# **Pearl Place Buildings I & 2**

**ADDENDUM II**

**September 22, 2006**

**Pearl Place**  
**Buildings 1 & 2**  
Portland, Maine

**L-SK-2**

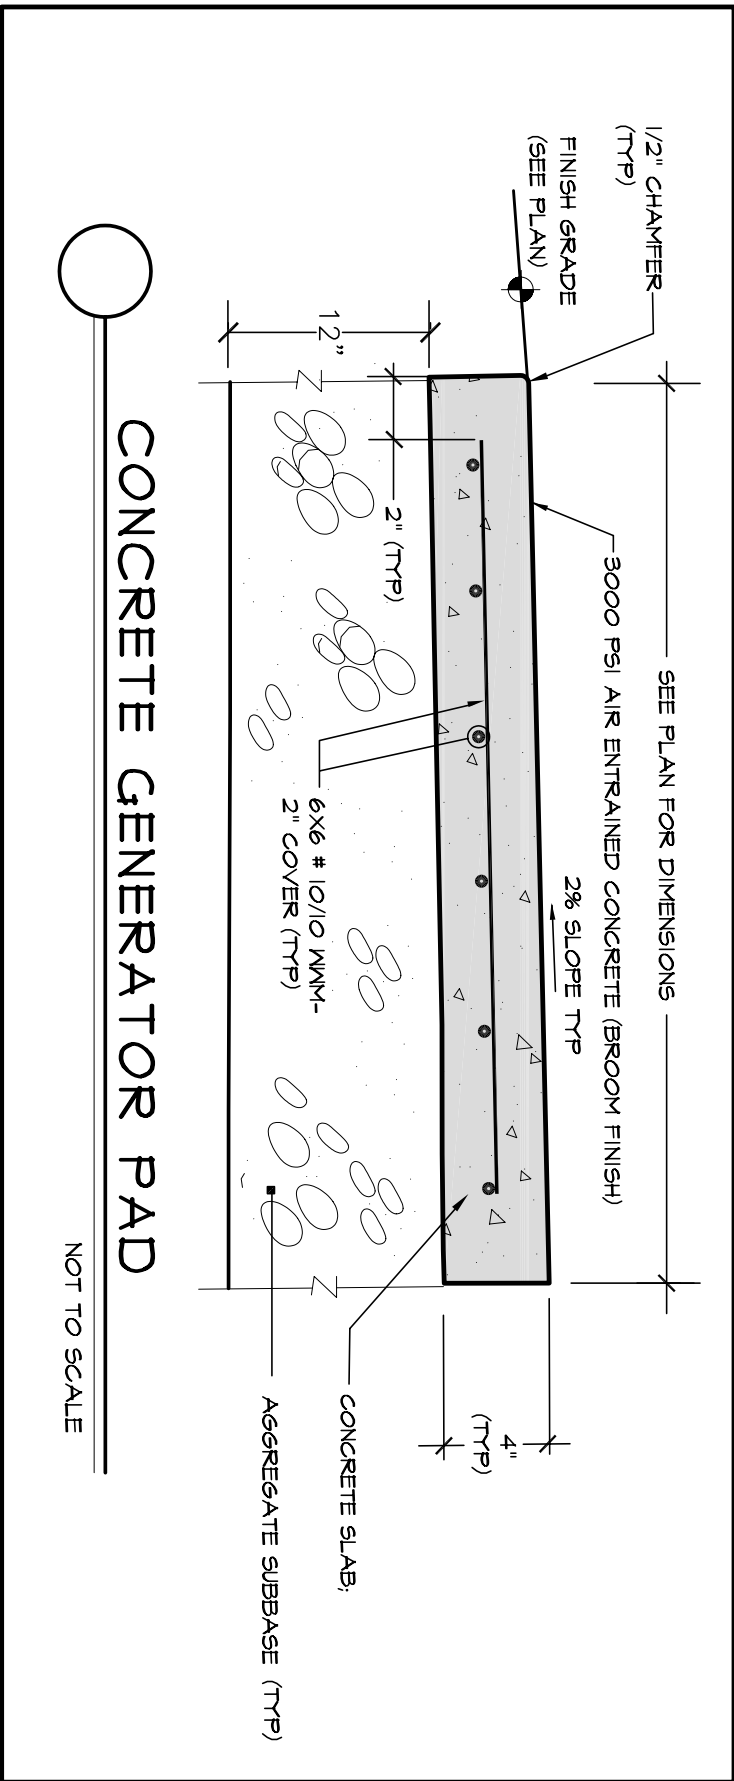
- L-1** Note # 12 Replace with:  
Owner shall be responsible for street opening permit.  
Contractor shall be responsible for all other permits within  
Street Right-of-Ways.
- L-2.0/L-2.1** Replace with: CONCRETE GENERATOR PAD DETAIL
- L-4** Detail 8 Replace with L-SK-3, DUMPSTER ENCLOSURE w/ GATE
- L1-5** 1. Detail 1 Change note indicating the hand/guard rails from aluminum to  
painted steel. Follow section 09900 for painting specifications.

DRAWING TITLE: GENERATOR PAD DETAIL  
(ADDENDUM # 2)

**2-HR SHAFT WALL**

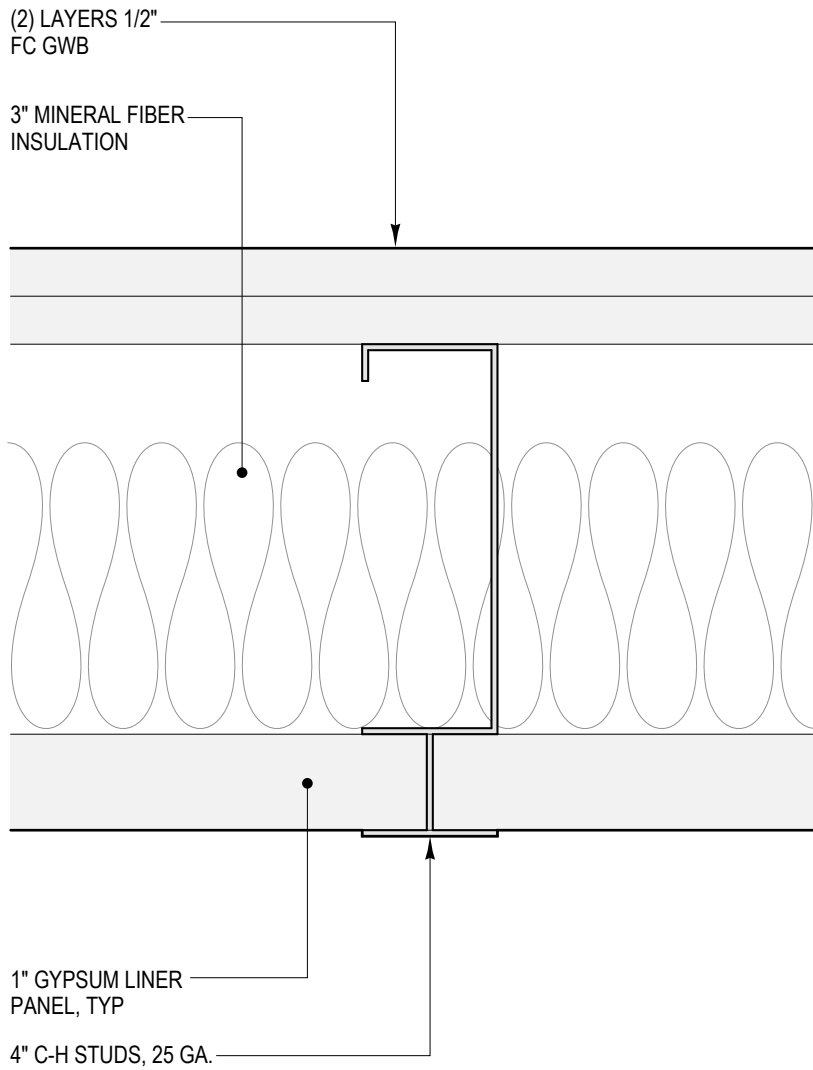
1. All partitions at chases that go through the floors of the Building 2 shall be 2HR  
rated, wall type 16 as shown on ASK 4 attached to this addendum

UL DES UL438  
TEST NO. RAL-OT-04-019  
STC 50

**7 FLOOR DRAIN/ ROLL-IN SHOWER DAM DETAIL**  
 REVISED BY ADDENDUM 2, 9/22/06  
 6" = 1'-0"

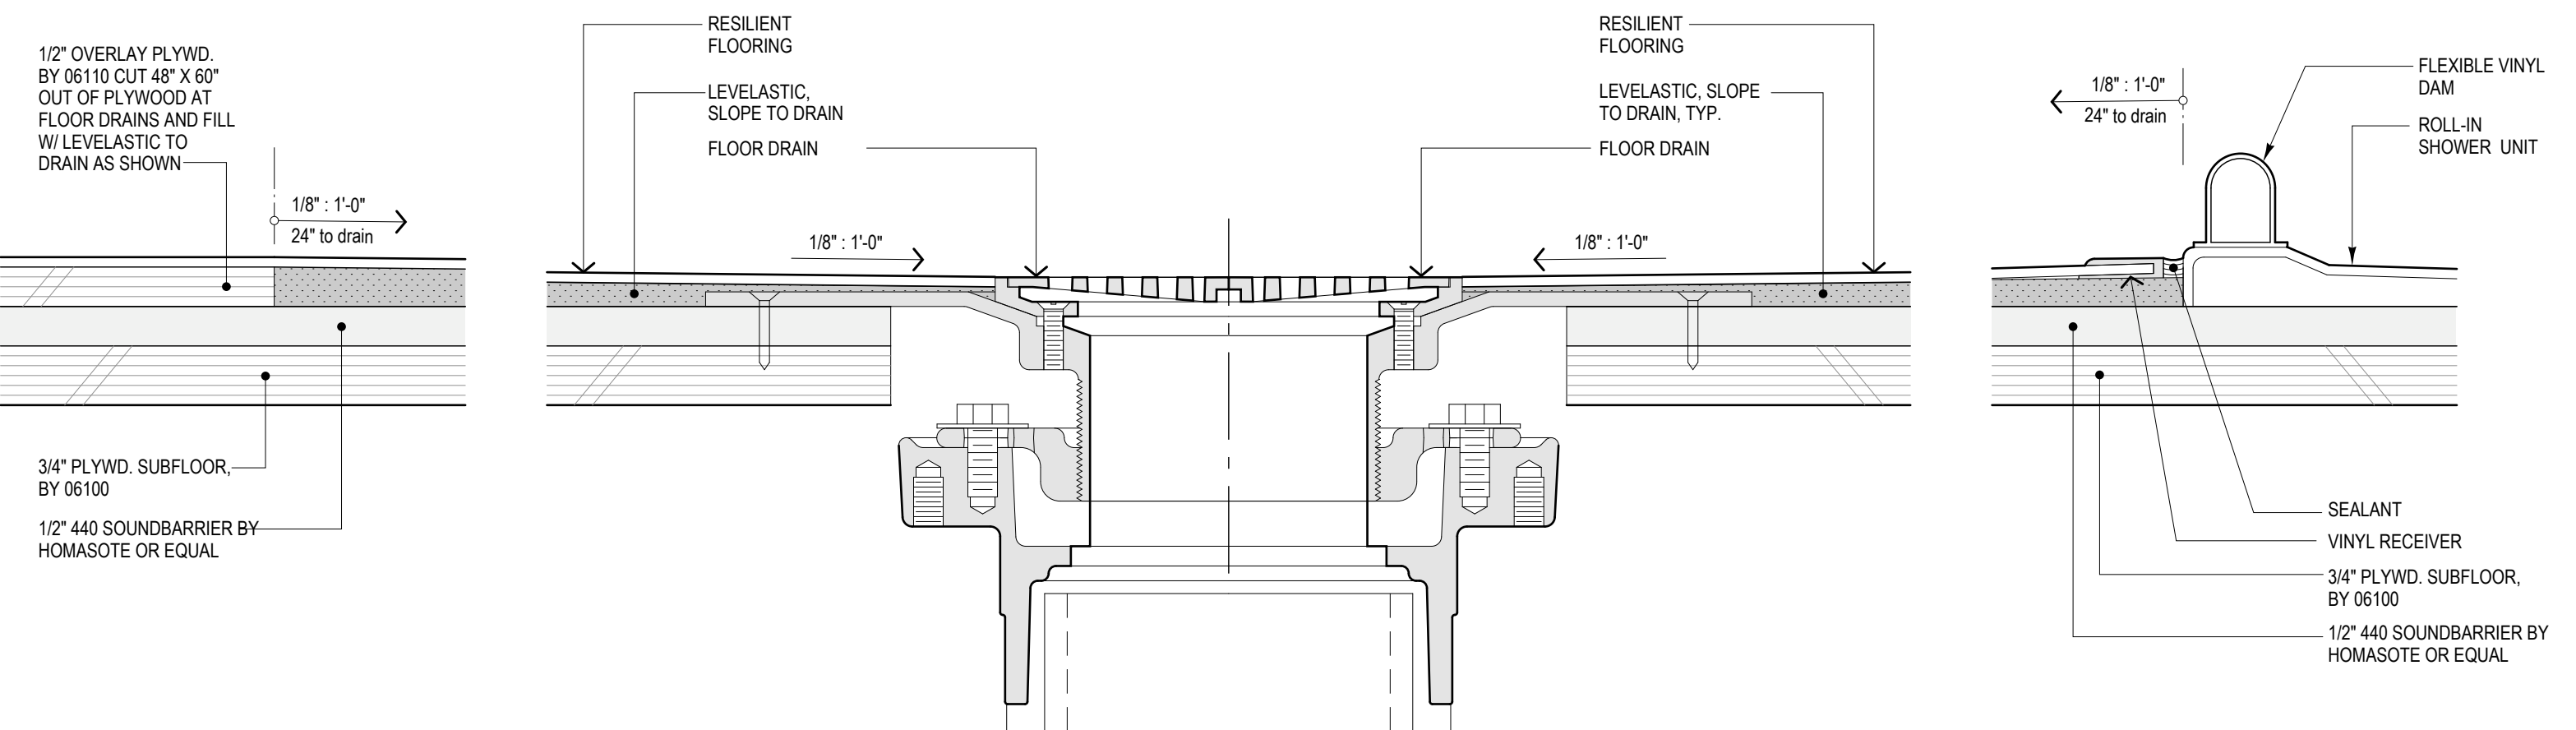
- A5.7** 1. Change Detail 7 as shown on ASK 5.

# WINDOW SCHEDULE (REVISED BY ADDENDUM 2)

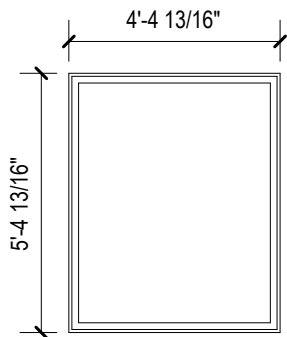
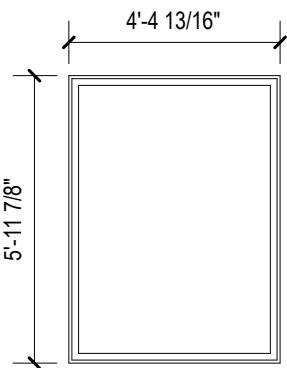
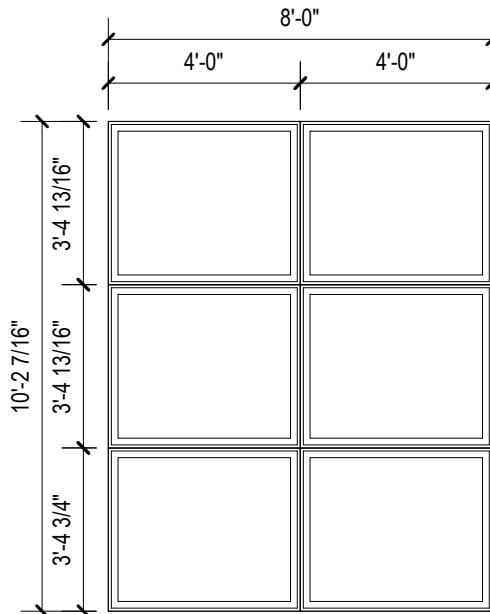
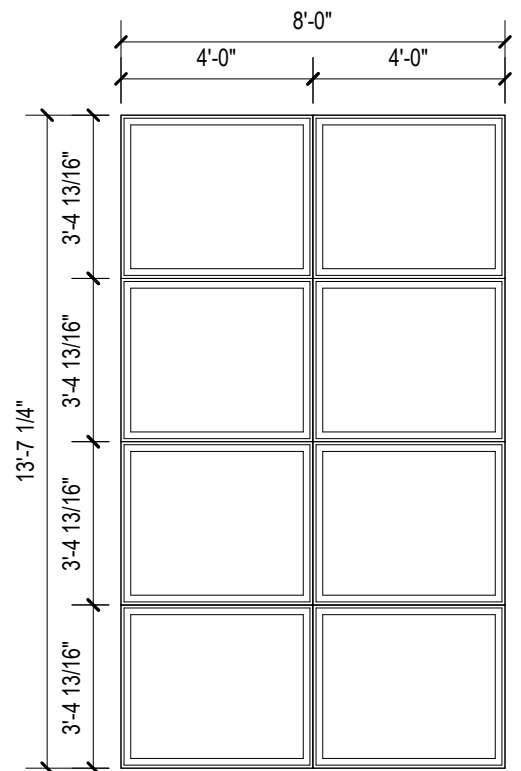
- A10.1** 1. Apply Alternate 5 from this addendum at following window units:  
Delete: W68, W70, W110, W112, W122, W124, W196, W194, W247, W249, W258, W260, W300, W302, W311, W313.  
Change per schedule shown on ASK 7: W111, W123, W248, W259, W301, W312.  
Revise the head jamb and sill details as shown on ASK 8a and 8b
2. At KEYED NOTES 1, 2, 3 delete “ by sect 08110” added by Addendum 1. Add the following: the window frames to be Fireframes as manufactured by Forster or equal. Finish color to match wood clad windows. Follow manufacturer’s specifications for installation requirements.

GENERAL			DETAILS			NOTES
Window No.	Rough Opening (WxH)	Type	Head	Jamb	Sill	
<b>BUILDING 1 - 2ND FLOOR</b>						
W57	4'-5 3/8" x 5'-5 3/8"	G	H12	J18	S8	
W69	4'-5 3/8" x 5'-5 3/8"	G	H12	J18	S8	
<b>BUILDING 1 - 3RD FLOOR</b>						
W111	8'-0 1/2" x 10'-3"	M	H12	J17	S8	
W123	8'-0 1/2" x 10'-3"	M	H12	J17	S8	
<b>BUILDING 2 - 2ND FLOOR</b>						
W195	4'-5 3/8" x 6'-0 3/8"	J	H12	J18	S8	
W206	4'-5 3/8" x 6'-0 3/8"	J	H12	J18	S8	
<b>BUILDING 2 - 3RD FLOOR</b>						
W248	4'-5 3/8" x 6'-0 3/8"	J	H12	J18	S8	
W259	4'-5 3/8" x 6'-0 3/8"	J	H12	J18	S8	
<b>BUILDING 2 - 4TH FLOOR</b>						
W301	8'-0 1/2" x 13'-7 3/4"	O	H12	J17	S8	
W312	8'-0 1/2" x 10'-3"	M	H12	J17	S8

SSK-8

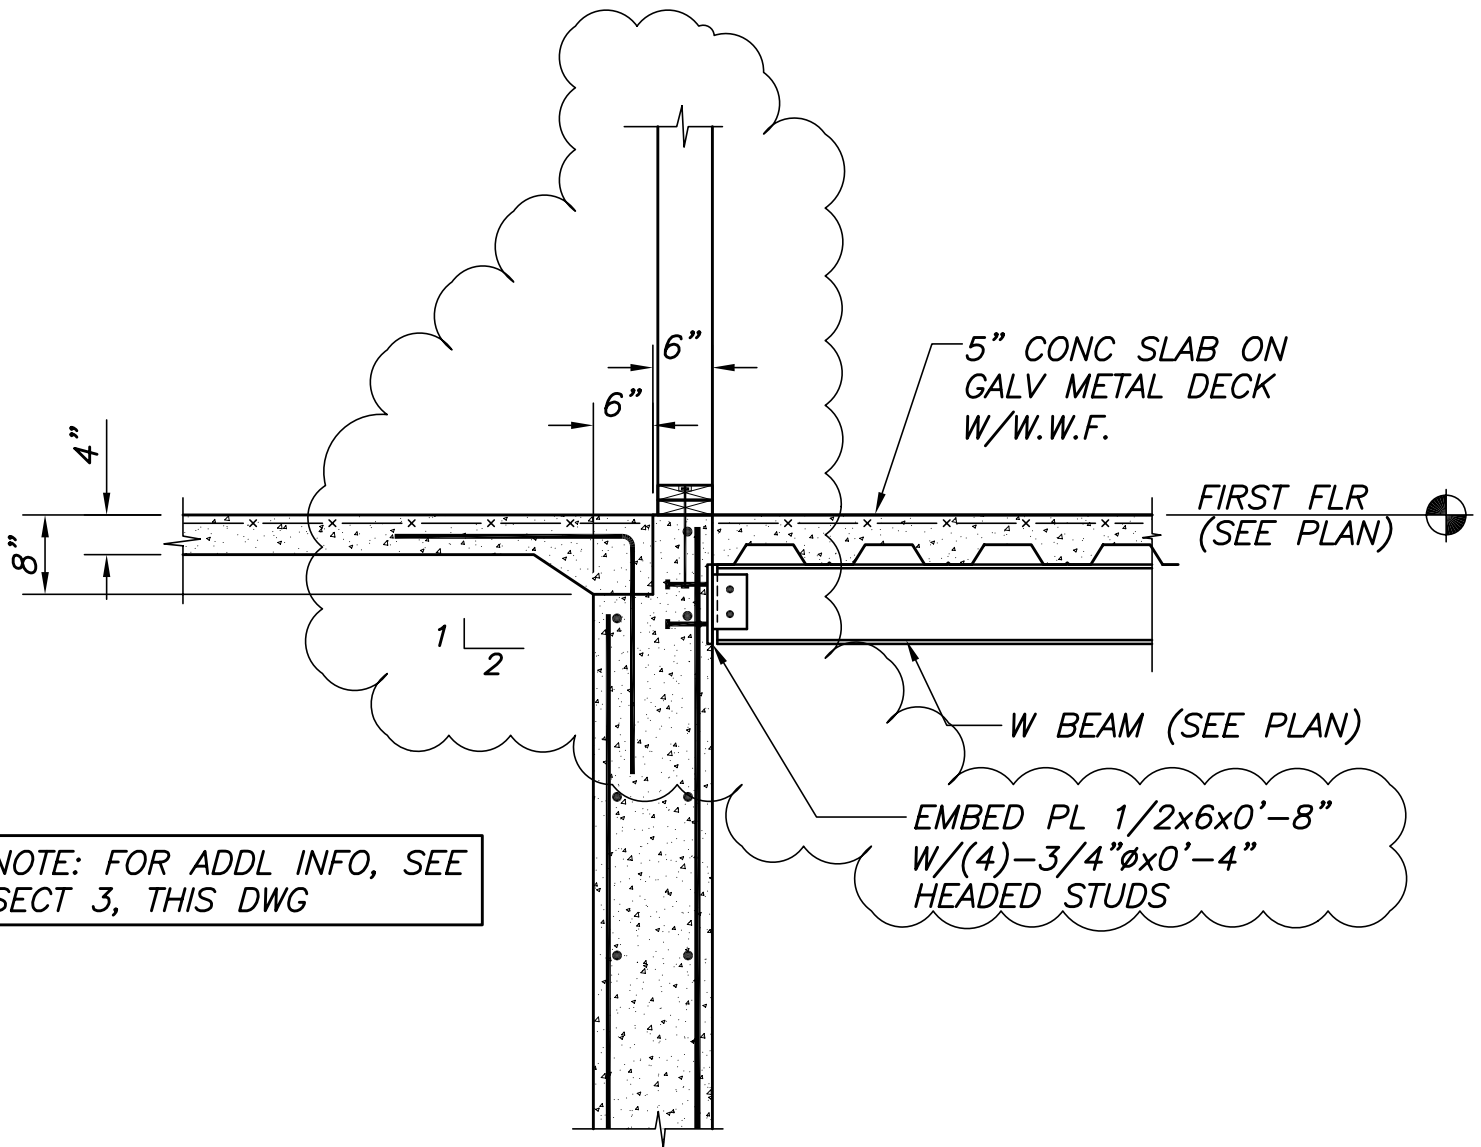
1. At retaining wall jog near Stair 2-1, change dimension from 4’-3 ½” to 4’-6”
2. For concrete slab on grade, delete the WWF and replace with fiber reinforcing.
3. Foundation walls with reference to Section 4/S2. are widened to 10” stem plus 6” shelf (See SSK-12)
4. At all holdown locations at interior shear walls, provide a Mark F4 footing constructed monolithically with the thickened /dropped slab.

**SSK-13**  
ADDENDUM NO. 2

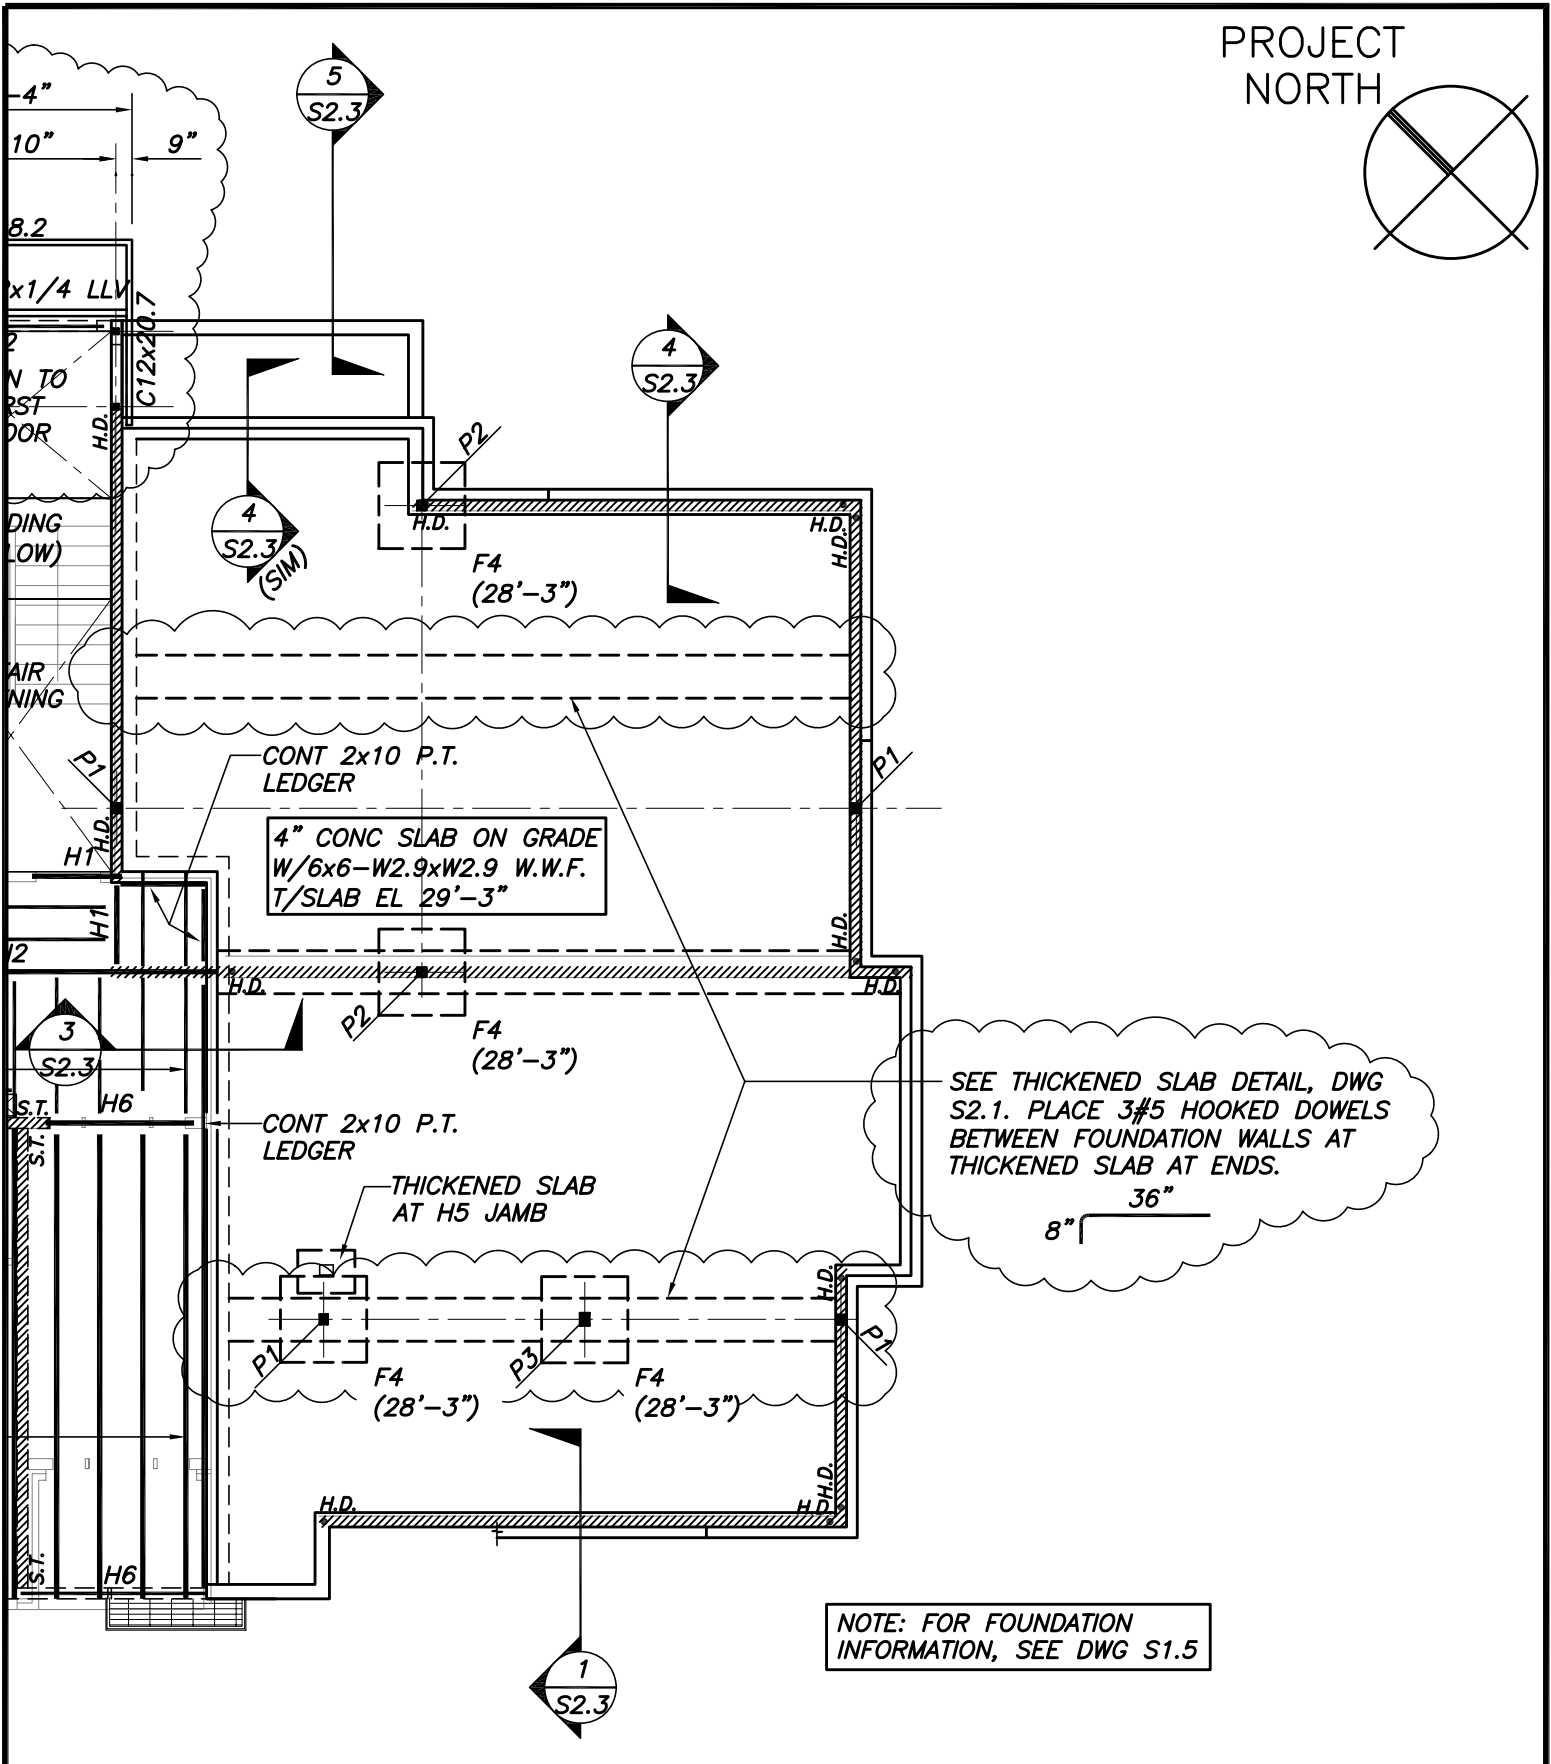
1. In Framing Note #6, change last sentence to read: “Fasten sheathing to trusses w/8d ring shank or spiral nails @ 6” oc. Place construction adhesive between top of truss and sheathing.”
2. At thickened slab and dropped slabs (5 locations) add following note: “ Place (3) #5 hooked dowels between foundation walls and thickened / dropped slabs at both ends. Hook to be 8” vertical (in wall) x 36” horizontal (into slab).

SEE THICKENED SLAB DETAIL, DWG S2.1. PLACE 3#5 HOOKED DOWELS BETWEEN FOUNDATION WALLS AT THICKENED SLAB AT ENDS.
